Sydney Football Stadium

**SSD 9835 Sydney Football Stadium Redevelopment,
Section 4.55 Modification -**

Precinct Village and Car Park (MOD 7):
Design Integrity Assessment Report
(Revision 9, September 2021)

7. Increased Permeability through Site

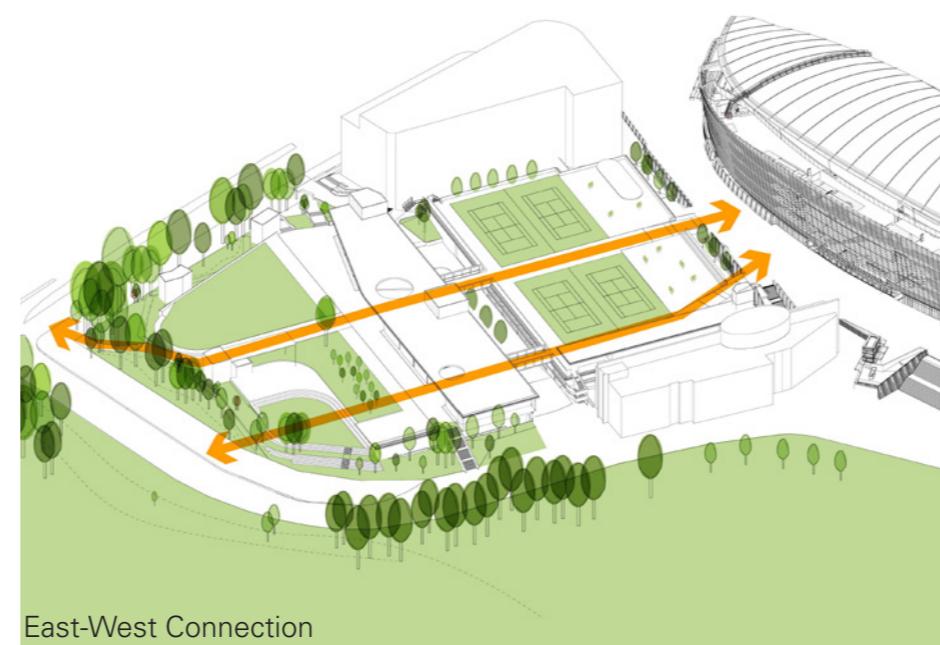
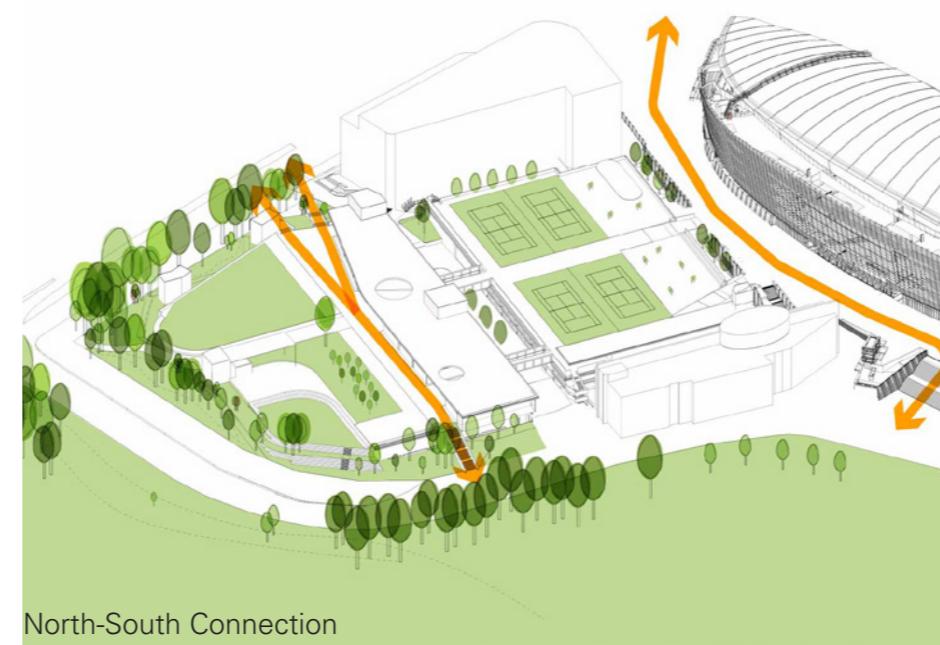
The proposed Precinct Village provides significantly improved pedestrian permeability and amenity across the MP1 Car Park site, due to the public Precinct Village and Event Plaza providing seamless connectivity from Moore Park in the west to the Stadium Plaza in the east and from Moore Park Road in the North to Driver and Avenue and Kippax Lake in the south. These pedestrian routes are distinctly separated from the vehicle routes within the site and also enjoy the amenity of F&B outlets, toilets and play and activity areas.

8. Scale and Legibility of Access in the South West Corner

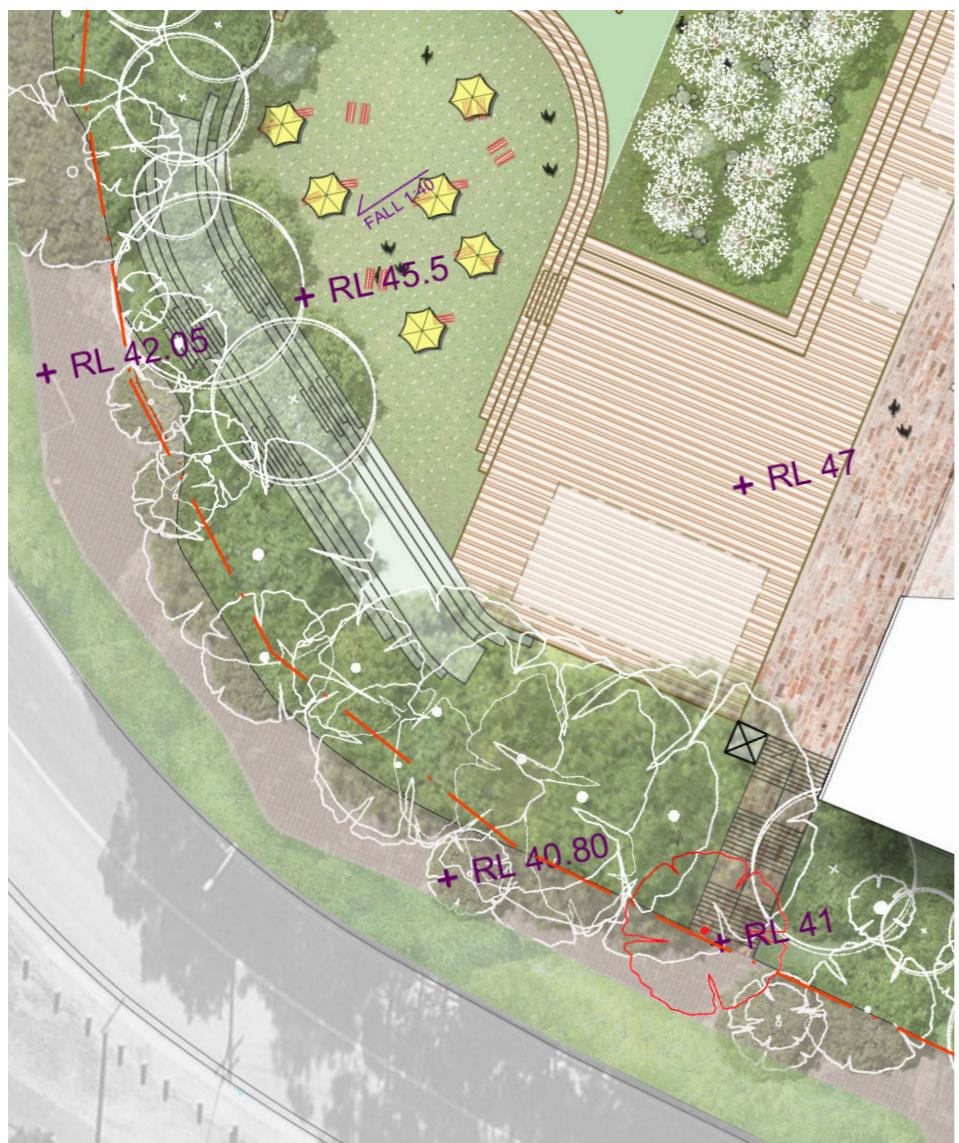
An open green area, sun filled facing Moore Park East is scaled to facilitate informal recreation and areas for green respite. The space lends itself for integrated terraces underneath rich heritage tree canopy as well as panoramic views to Kippax Lake to create an active gathering space area, people watching and spectating over Moore Park East.

The green area is framed with additional timber terraces adjacent to proposed Eat Street and pergolas to encourage informal seating and eating opportunities whilst retaining a more intimate scale and privacy. It also creates opportunities to act as an amphitheatre to create an informal audience or spectator zones for small events.
